# UNITED STATES PATENT AND TRADEMARK OFFICE

<b>Office Action Summary</b>	<b>Application No.</b> 10/061,458	<b>Applicant(s)</b> DINH ET AL.	
	<b>Examiner</b> Alvin J. Stewart	<b>Art Unit</b> 3774

## **DETAILED ACTION**

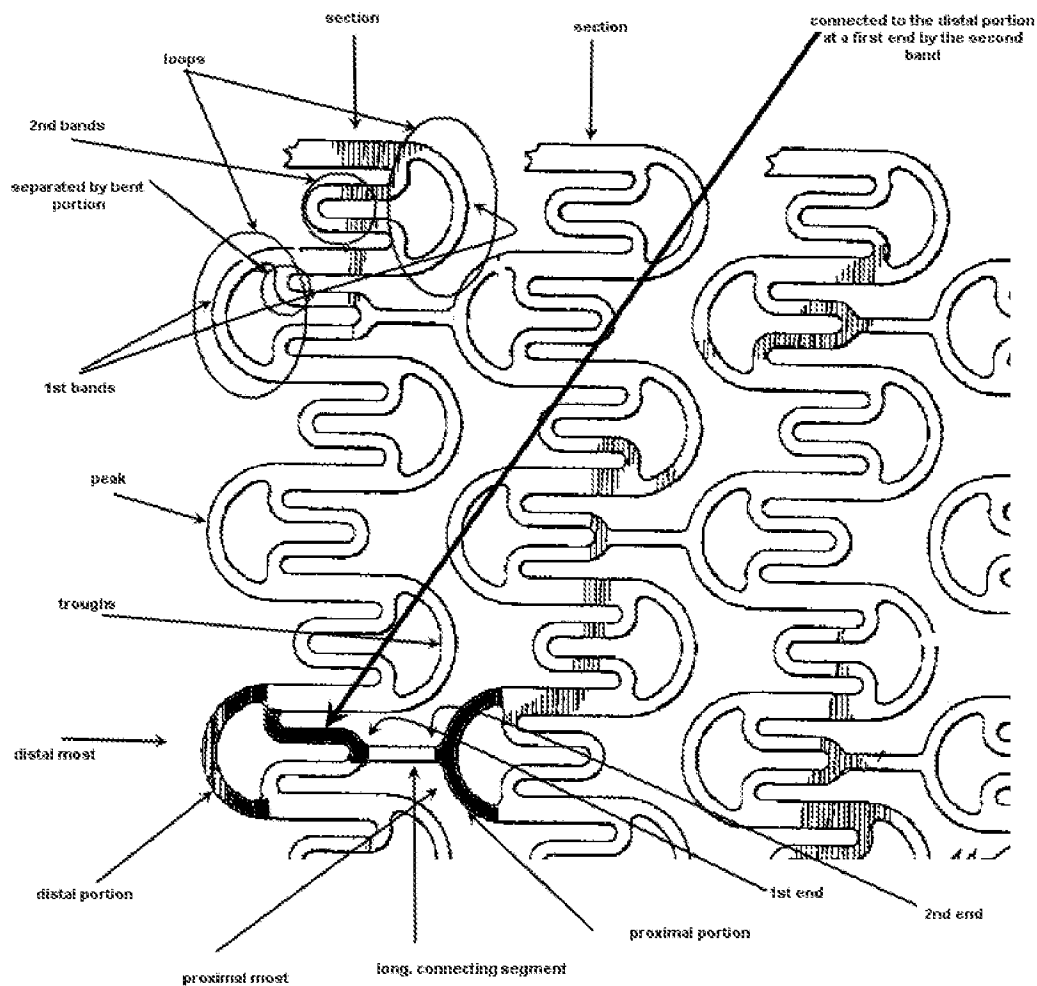
Allen et al discloses a stent having serpentine circumferential bands connected one to the other, the bands include first serpentine circumferential bands (58) and second serpentine circumferential bands (3). The first and second bands are connected by a plurality of longitudinal connectors (50).

Regarding claims 25-27, see Figure below.

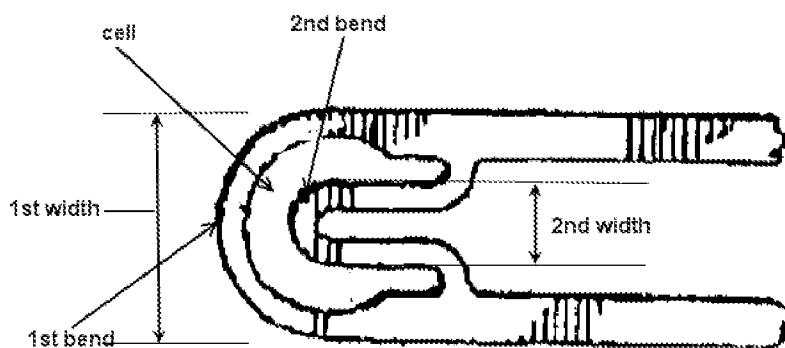
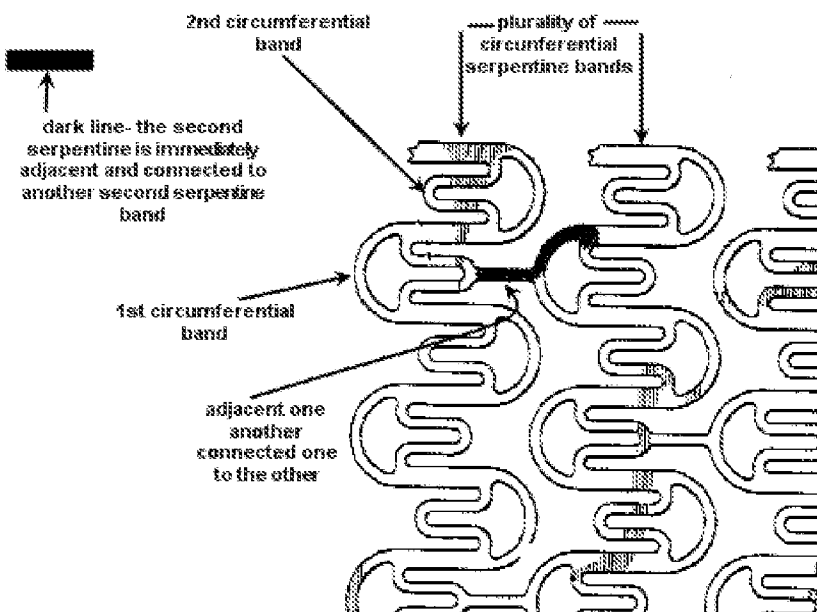
Regarding claims 28-33, see figure below in order to clarify how the Examiner interpreted the claims. With respect to the language: “at least one second serpentine circumferential band immediately adjacent to and connected to another second serpentine circumferential band by a longitudinal connector”, the examiner interpreted the claims as follow: the at least one second serpentine band is immediately adjacent to and connected to another band by connector 50 and by the first circumferential band. Every first serpentine

circumferential band being adjacent to a second serpentine circumferential band and every second serpentine circumferential band being adjacent to a first serpentine circumferential band.

Wherein the first bend and the second bend are oriented to the same direction and pointing away from the cell.
